[Docket No. FAA-2016-4228; Directorate Identifier 2015-NM-107-AD]

Airworthiness Directives; Airbus Airplanes

ACTION: Notice of proposed rulemaking (NPRM).

Figure 1 to paragraph (i)(7) of this AD – Design A of the Passenger Oxygen Containers Affected by this AD

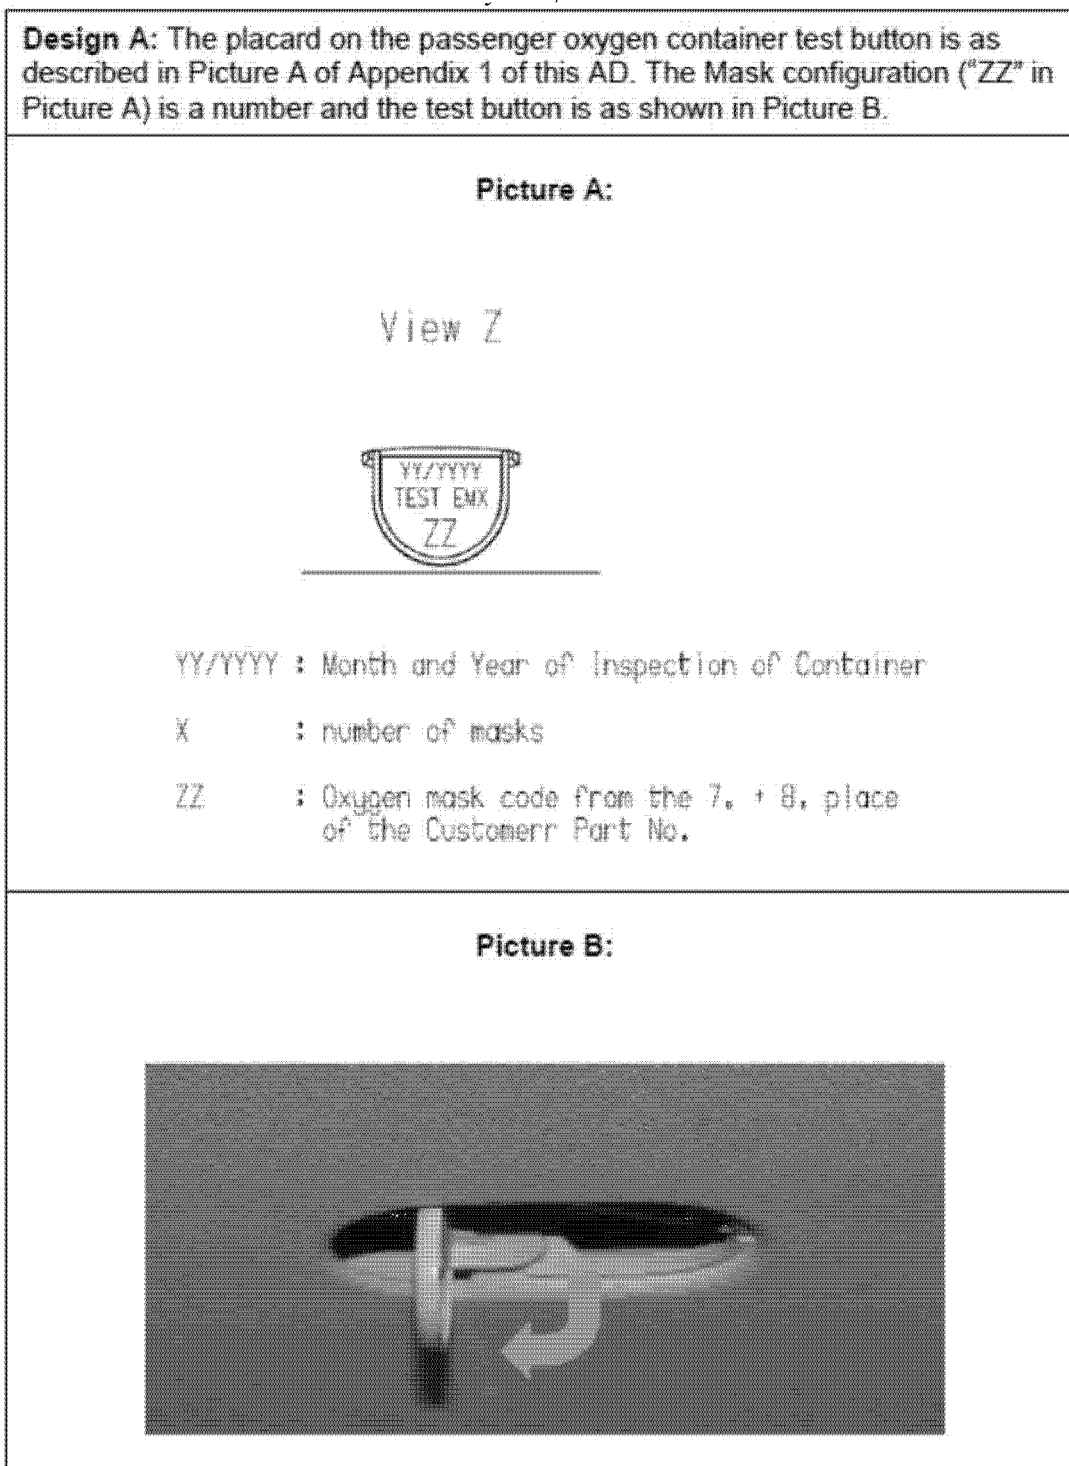
We have added Note 2 to figure 1 to paragraph (i)(7) of this AD, which provides information to clarify information presented in figure 1 to paragraph (i)(7) of this AD.

(7) The requirements of paragraphs (g) and (h) of this AD apply only to passenger oxygen containers that are Design A, as defined in figure 1 to paragraph (i)(7) of this AD.

Note 2 to figure 1 to paragraph (i)(7) of this AD: For "Design A," the placard on the passenger oxygen container test button is as

described in "Picture A" in figure 1 to paragraph (i)(7) of this AD. The mask configuration ("ZZ" in "Picture A") is a number, and the test button is as shown in "Picture B."
